## Los Angeles Regional Water Quality Control Board

### **REVIEW OF THE CITY OF EL MONTE'S DRAFT WATERSHED MANAGEMENT PROGRAM, PURSUANT TO PART VI.C OF THE LOS ANGELES COUNTY MUNICIPAL SEPARATE STORM SEWER SYSTEM (MS4) PERMIT (NPDES PERMIT NO. CAS004001; ORDER NO. R4-2012-0175)**

**SUBJECT:** COMMENTS ON DRAFT WATERSHED MANAGEMENT PROGRAM, SECTION 1.9, REASONABLE ASSURANCE ANALYSIS

Figure A. Model predicted results from RAA Report for City of El Monte

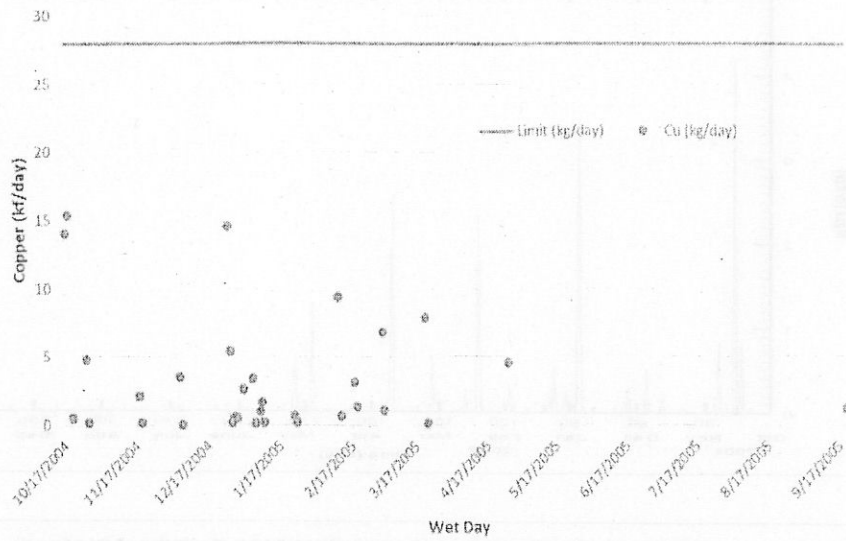
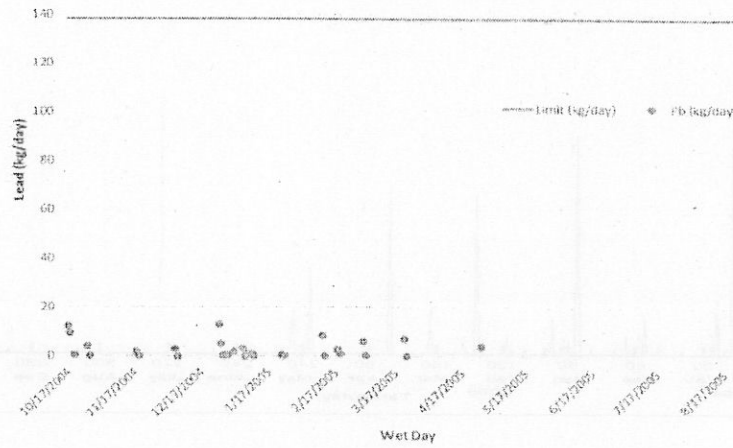
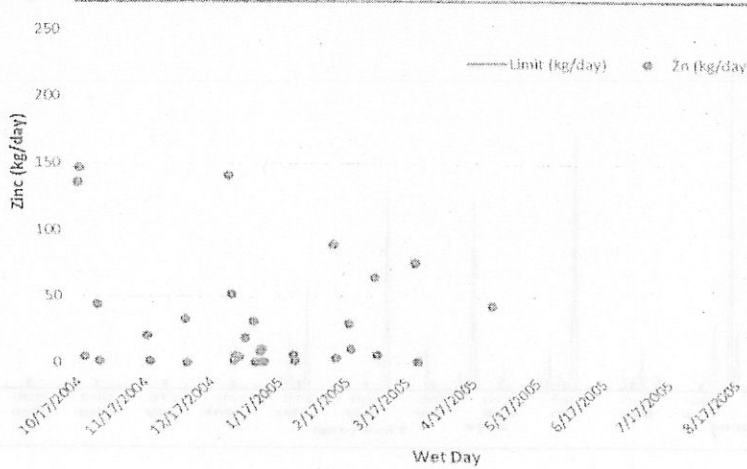
1. The model predicted mass contributions of pollutants from the City shown in Table 1-6 through Table 1-14 and Figure 1-8 through Figure 1-11 are not consistent with those values directly from the model output (see attached Figure A. and Figure B. for an example) . As such, the conclusion that no pollutant reduction is required should be re-evaluated.
